UNITED STATES PATENT AND TRADEMARK OFFICE

APPLICATION NO.	FILING DATE	FIRST NAMED INVENTOR	ATTORNEY DOCKET NO.	CONFIRMATION NO.
10/600,088	06/20/2003	Mark B. Knudson	14283.2US01	9155
7590 04/29/2005			EXAMINER	
Merchant & Gould P.C. P.O. Box 2903 Minneapolis, MN 55402-0903			MENDOZA, MICHAEL G	
			ART UNIT	PAPER NUMBER
			3731

Office Action Summary	Application No.		Applicant(s)	
	10/600,088		KNUDSON ET AL.	
	Examiner		Art Unit	
	Michael G. Mendoza		3731

Figure 4

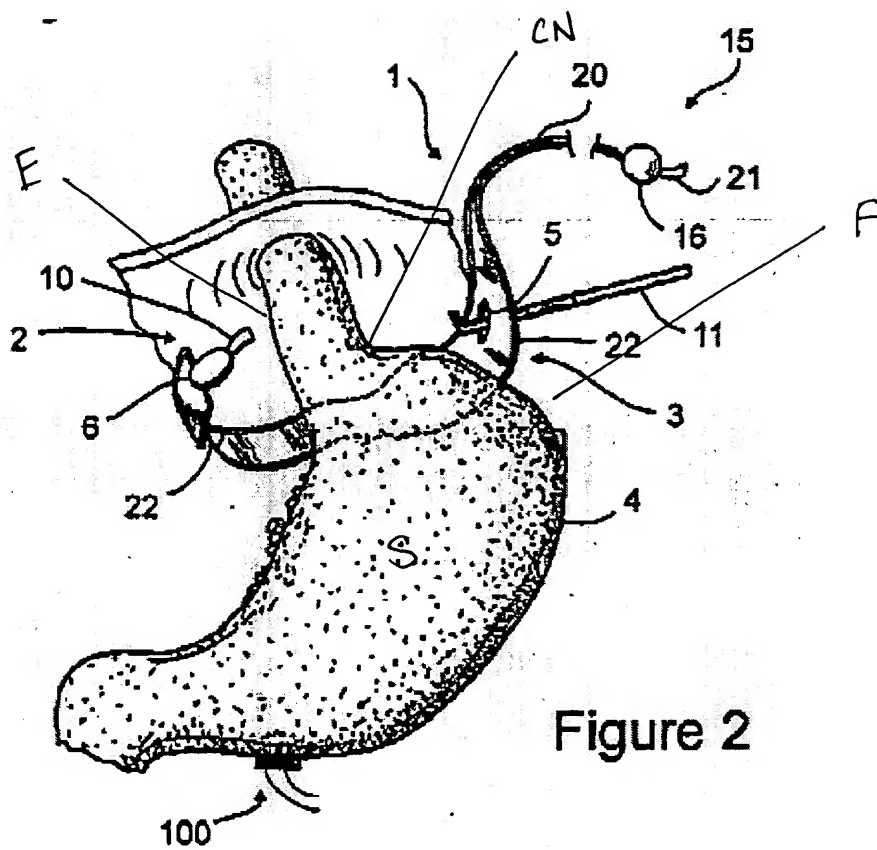
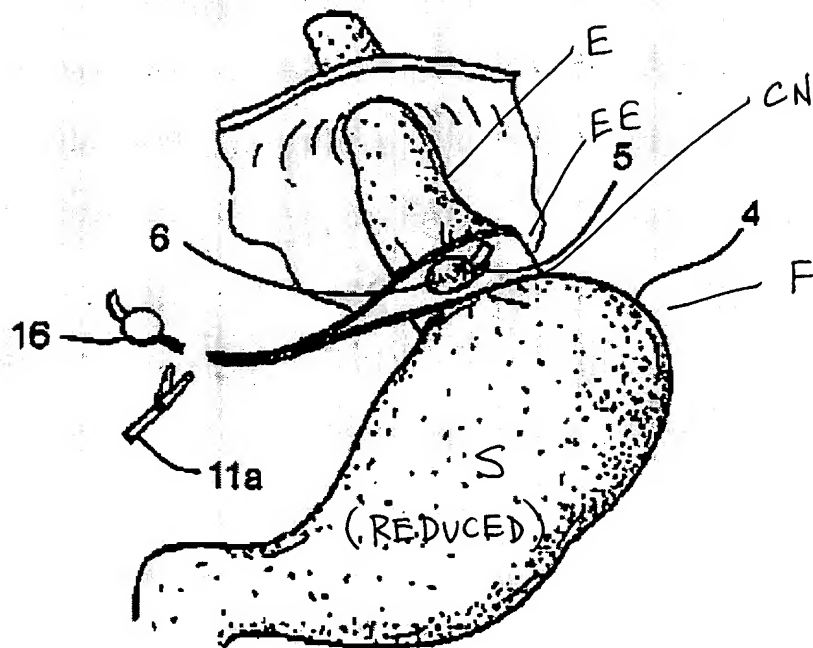
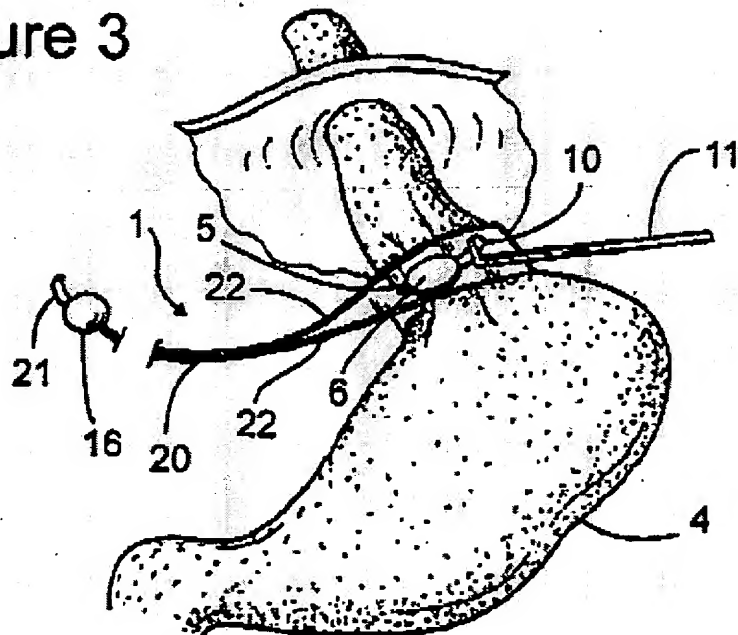
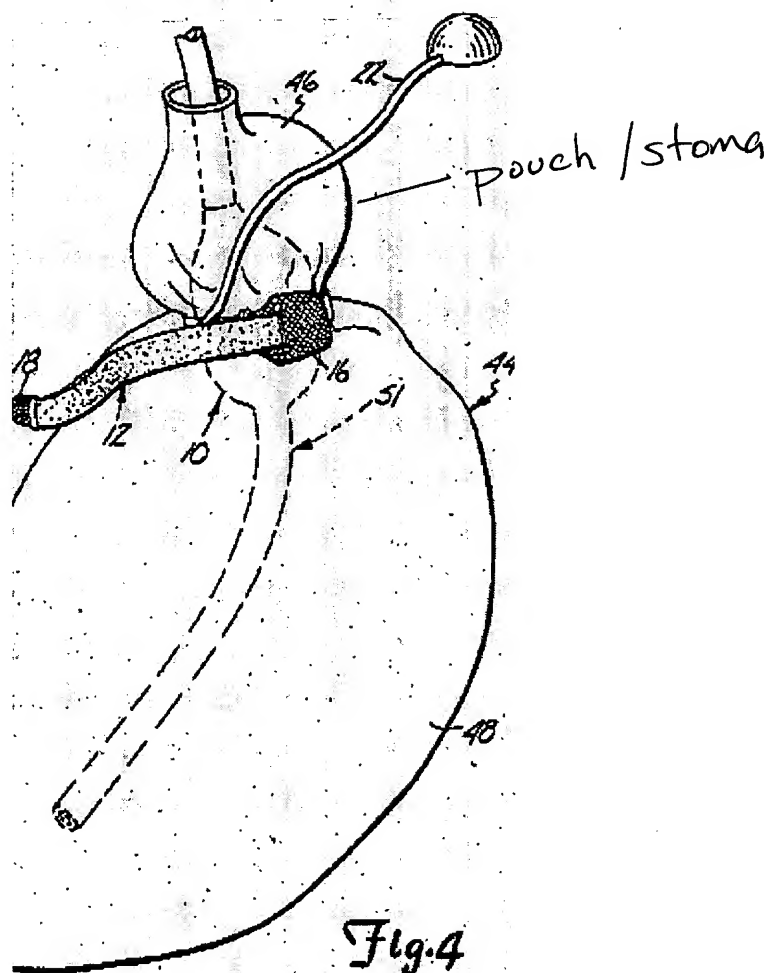
1. Applicant's arguments filed 18 January 2005 have been fully considered but they are not persuasive. The Applicant argues that the band of Cigaina is not place around the esophagus and that the band forms a pouch above the band. As shown in figures 2-4 Cigaina does teach that a band is placed around the esophagus. Cigaina does not show that a pouch is form above the band. The band is used to reduce the size of the stomach (under the band) as shown if figures 2-4.

cardiac notch position; wherein the element includes a material positioned loosely on the esophagus and fundus and the adjusting includes gathering and securing the gathered material along a length of the element; wherein the element is secured to either the esophagus or the stomach to restrict movement of the element relative to a final positioning of the element; wherein the securing includes providing selected areas of the element with tissue in-growth areas (see figs. 2-4); and wherein the element includes a securing member 6 for securing the element.

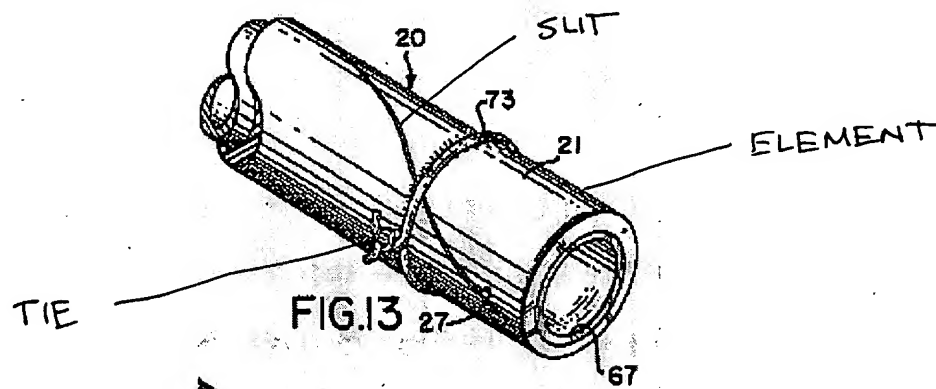
12. Forsell teach a device with a common implant for electrically stimulating the cardia sphincter to increase sphincter tonus. Therefore, it would have been obvious to one having ordinary skill in the art at the time the invention was made to use the implant of Forsell to allow the patient at any time to control the treatment of heart and reflux disease when various needs arise over a day, so that the patient always is satisfied (pg. 1, [0005]).
